Serial: HNP-08-049  
10 CFR 50.90

DOCKET NO. 50-400/LICENSE NO. NPF-63  
REQUEST FOR LICENSE AMENDMENT  
TECHNICAL SPECIFICATION 3.7.5a

Subject: Request for License Amendment of Technical Specification 3.7.5a,  
"Ultimate Heat Sink" to recover margin in Main Reservoir minimum  
allowed level

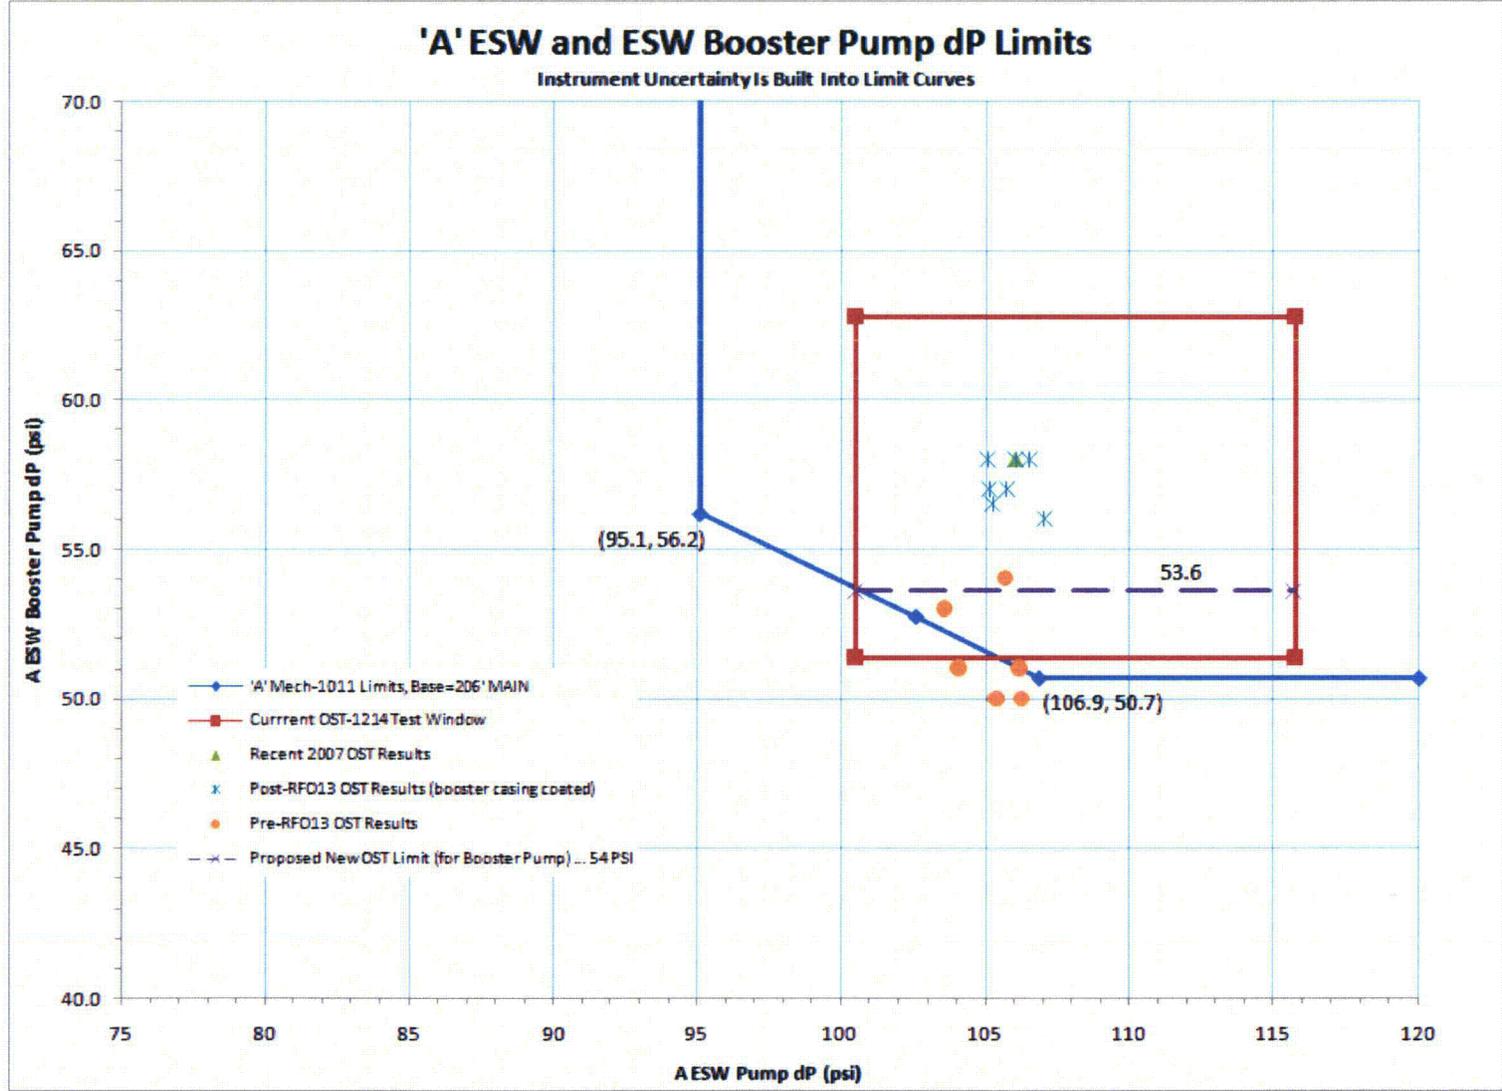
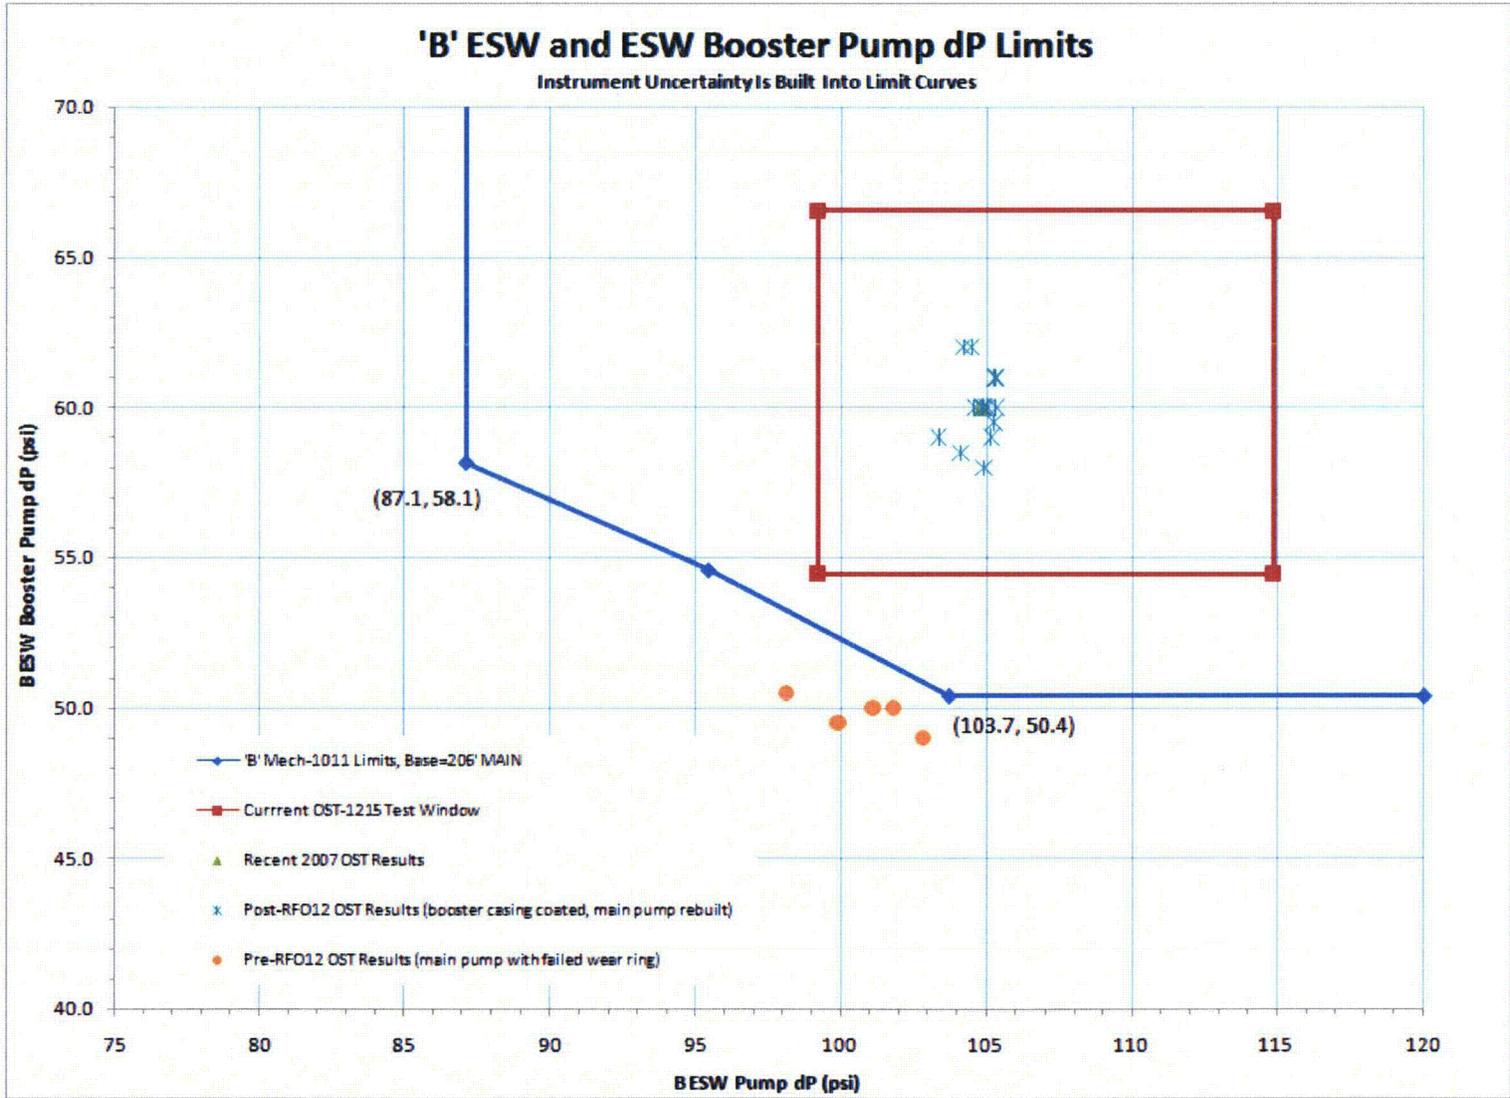
Since the ESW Pumps and ESW Booster Pumps both contribute to ESW pressure inside containment, HNP-M/MECH-1011 provides the minimum allowable pump differential pressures (dP) for both pumps for each train on a single graph. This allows for various combinations of limits between the ESW and ESW Booster Pumps. It also graphs the current Operations Surveillance Test (OST) limits and some recent and historical OST data against the new pump dP limits. These graphs are shown on pages 10 and 11 of Enclosure 1.

From the graphs, it can be seen that recent OST results are all greater than the proposed pump dP limits. This data indicates that the pumps are not likely to challenge the new limits in the near future. The graphs also show that current 'A' train OST limits are truncated by the new limits. As a result, OST-1214 (ESW System Operability, Train A) will need to be revised. HNP intends to raise the minimum allowable pump dP for the 'A' Booster Pump to 53.6 PSID without changing existing 'A' ESW Pump limits. All 'B' train OST-1215 (ESW System Operability, Train B) limits (ESW Pump and ESW Booster Pump) remain unaffected.

As noted in Section 4.2, the minimum OST-1214 differential pressure limit for the 'A' ESW Booster Pump will need to be increased to 53.6 PSID. Recent OST data shows that 'A' ESW Booster Pump should continue to remain above this new minimum limit. No changes are required for the 'A' ESW Pump limits.
